Planning & Zoning Board Meeting

ZONING MEMORANDUM

Meritage Homes- Elevation/ Architectural Plans Hillside Groves (The Reserve PUD) Applicant: Meritage Homes

Meritage Homes 4R05 (Formerly Bluebell)

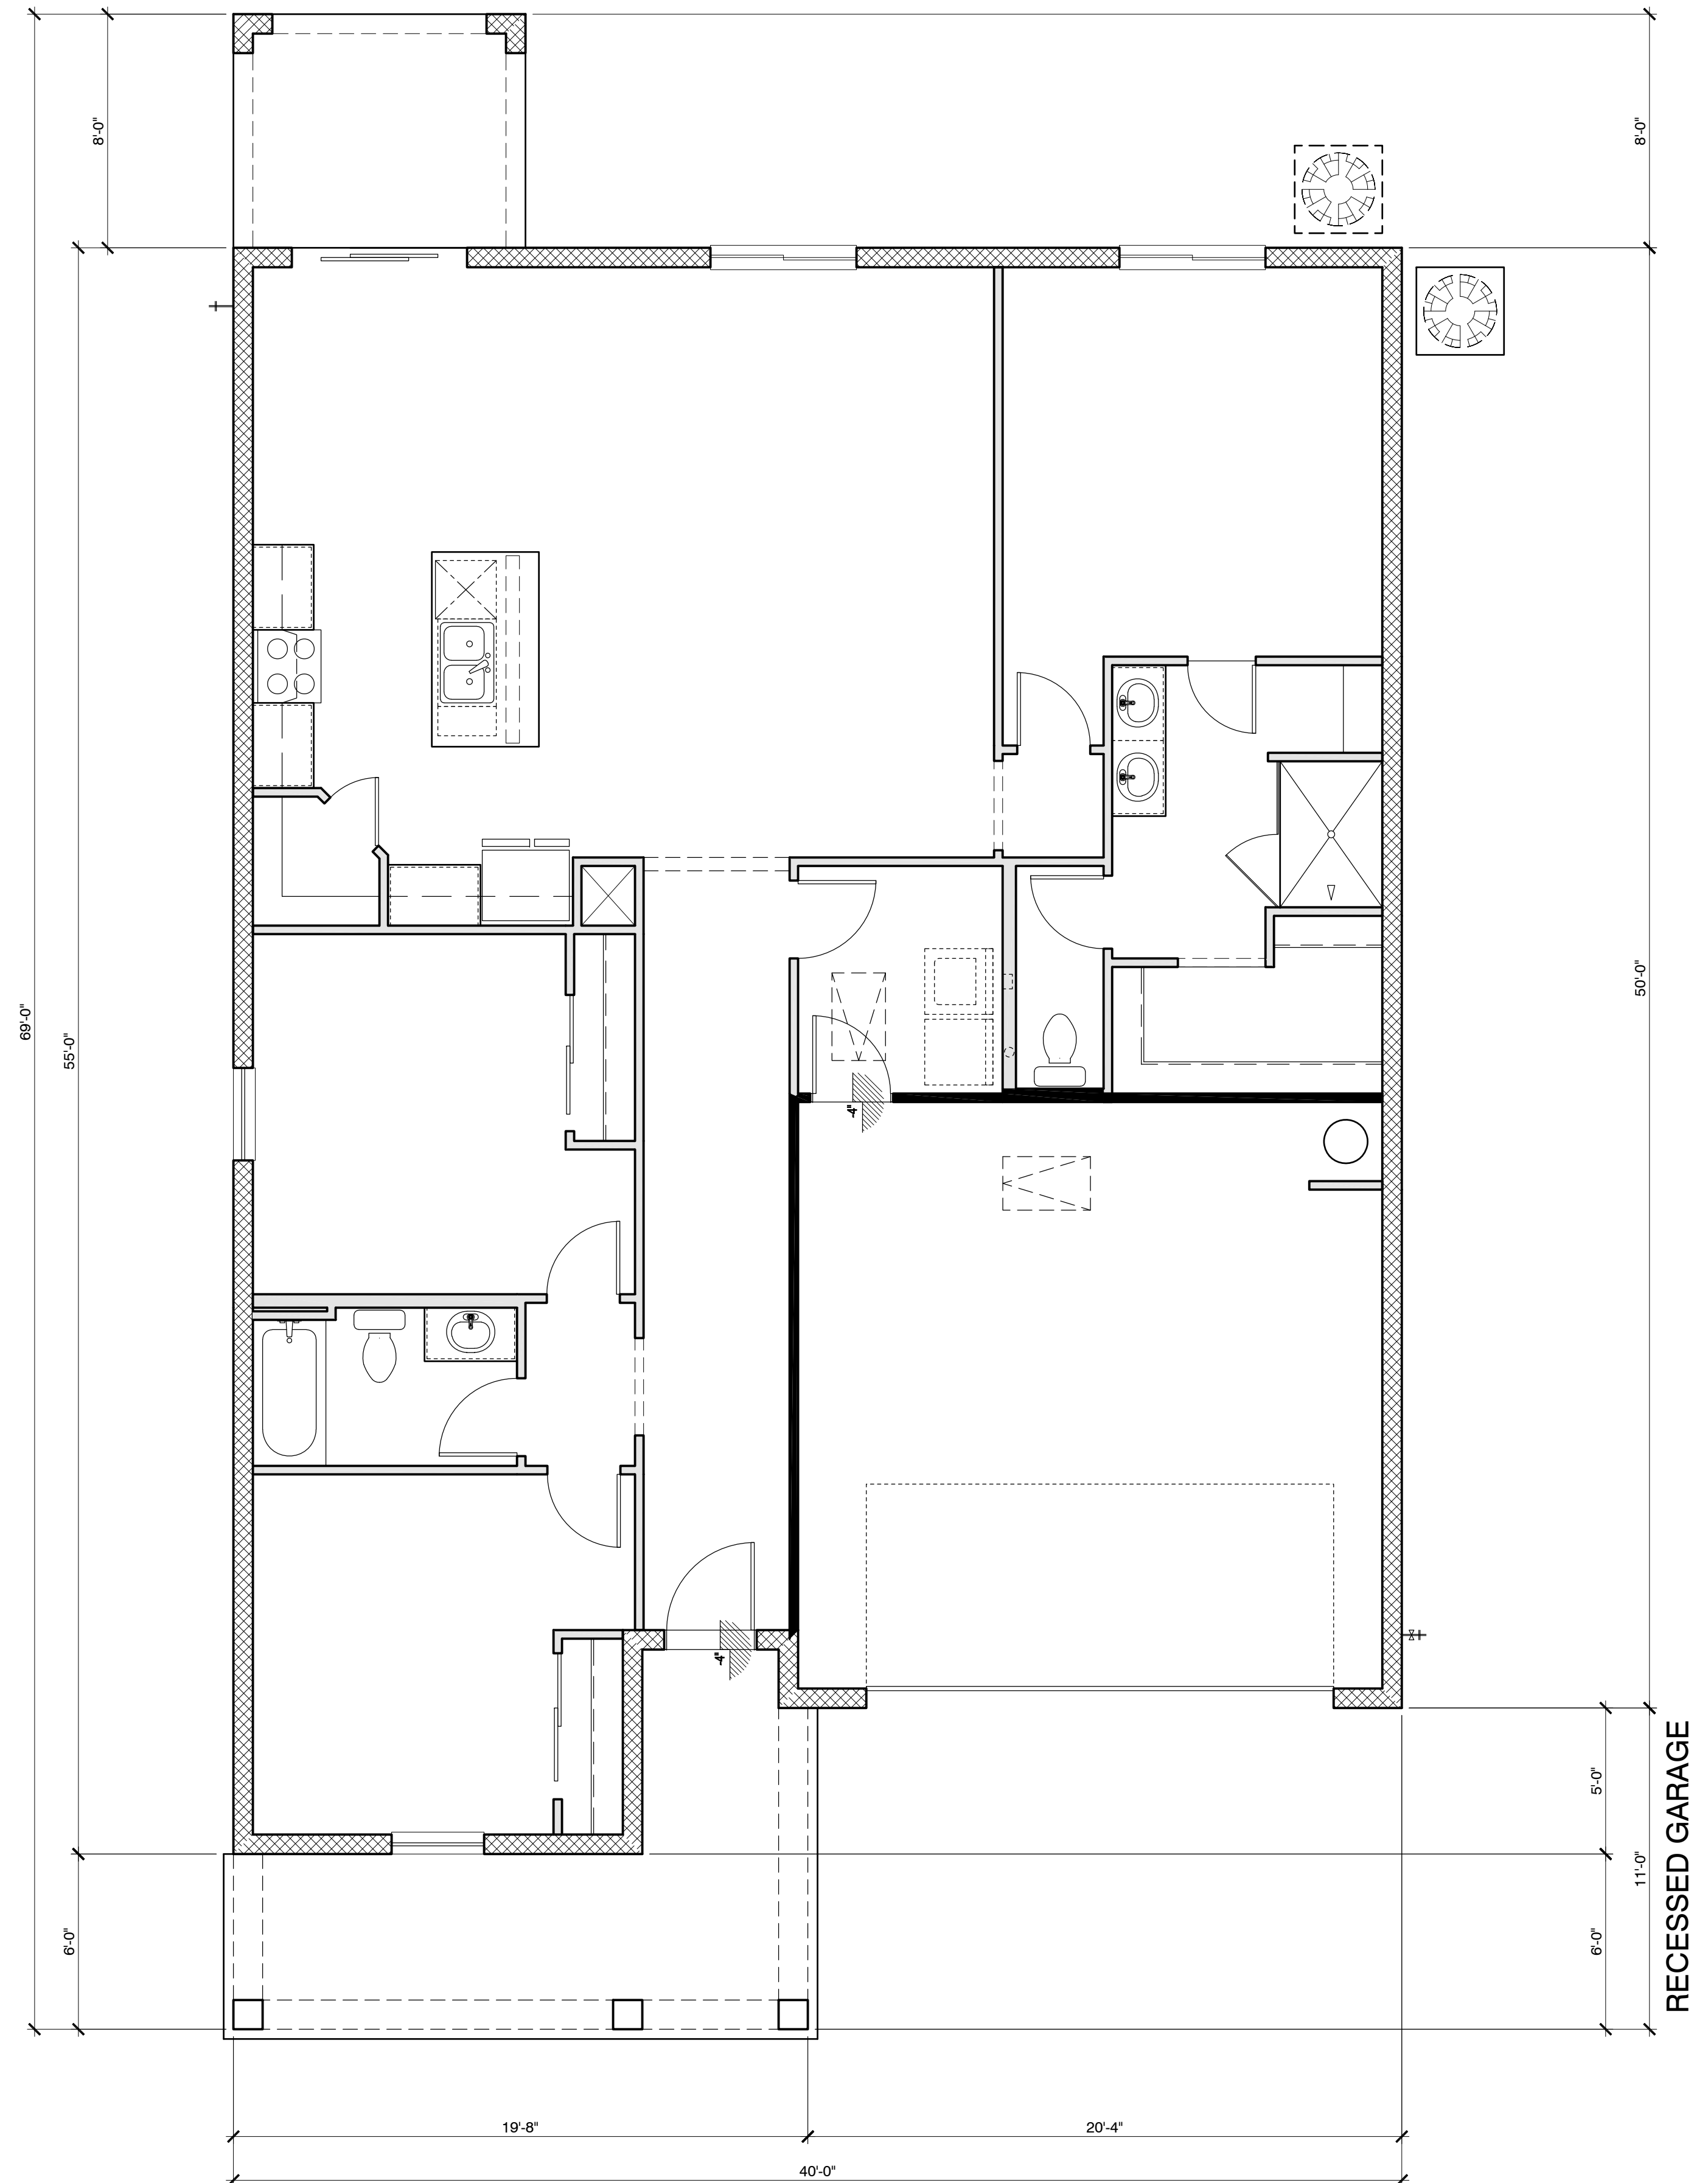
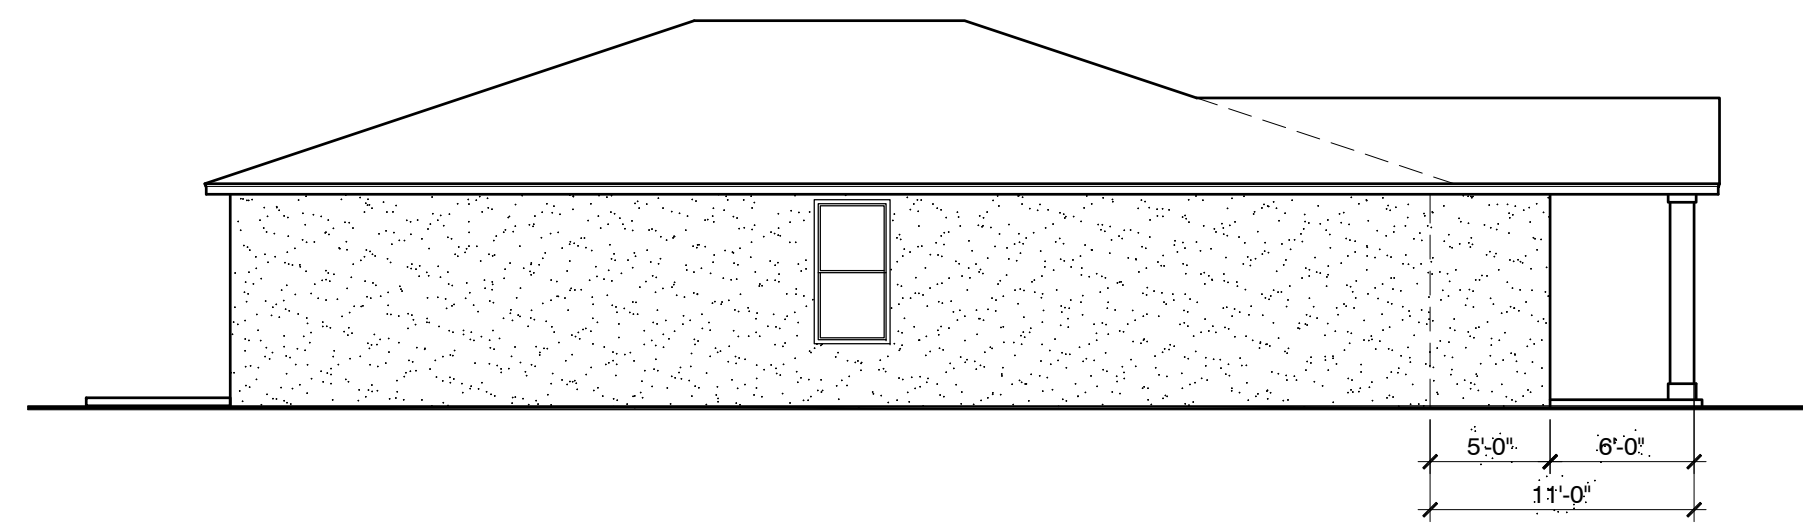
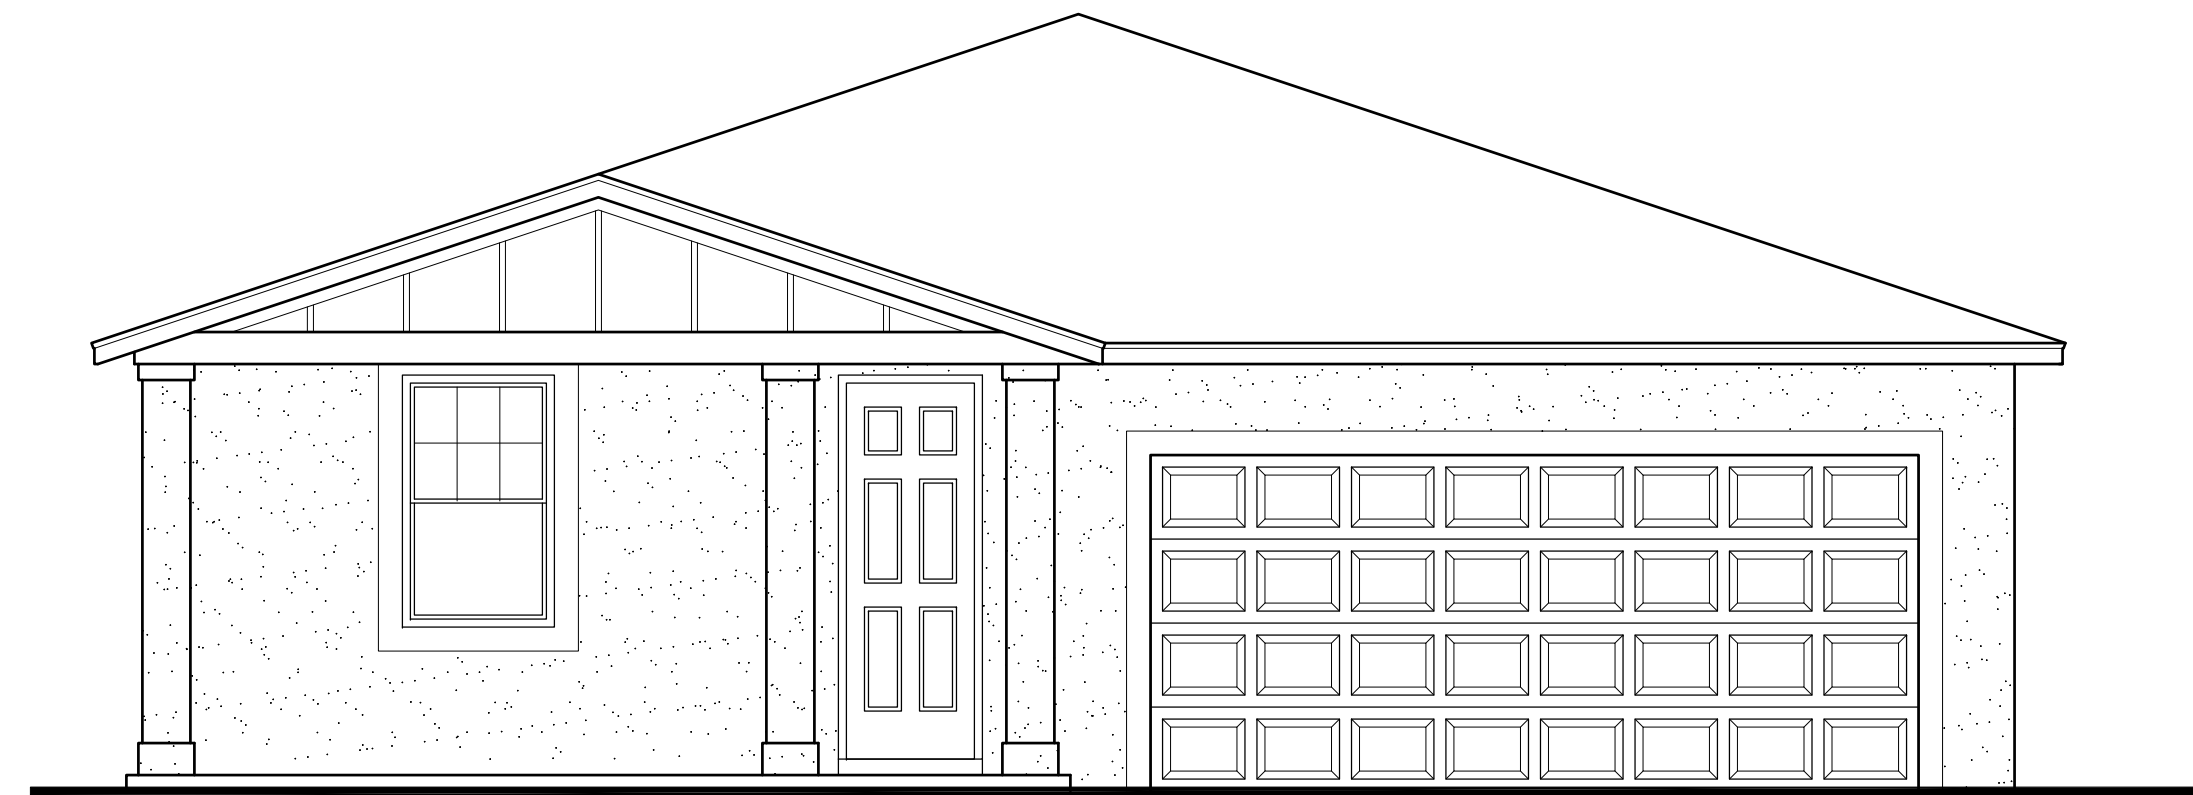
The proposed models appear to provide porches and recessed garages consistent with LDC Sec. 4.06.02 (A) (2) and (3). Additional detail on the porches would be helpful though to determine if they are at or above grade or have articulation designating them as usable front porches. As an example, none of the porches show railings as part of the design.

The proposed elevations show what appears to be stonework and varying materials on the models, however no product types, colors or materials are identified on the plans. The elevation plans need to be revised to demonstrate and specify materials to ensure that they are consistent with the following LDC Sections which state:

The proposed elevations do not identify the roof materials to be used nor detail on eave design. The plans need to be revised to demonstrate and specify roof materials and eaves detail to ensure that they are consistent with the following LDC Sections:

The application provides some of these details but not all that are required for each of the facades. Consistent with LDC Sec. 4.06.03, the plans need to be revised to show and label the front, side, and rear facade elevations for each model and identify the specific architectural details on each façade, demonstrating how they are consistent with the type and quantity required in LDC Sec. 4.06.03 (C).

Recommendation: The model elevations should be revised consistent with the requirements identified in the review comments below and be brought back to the Planning and Zoning Board for consideration.
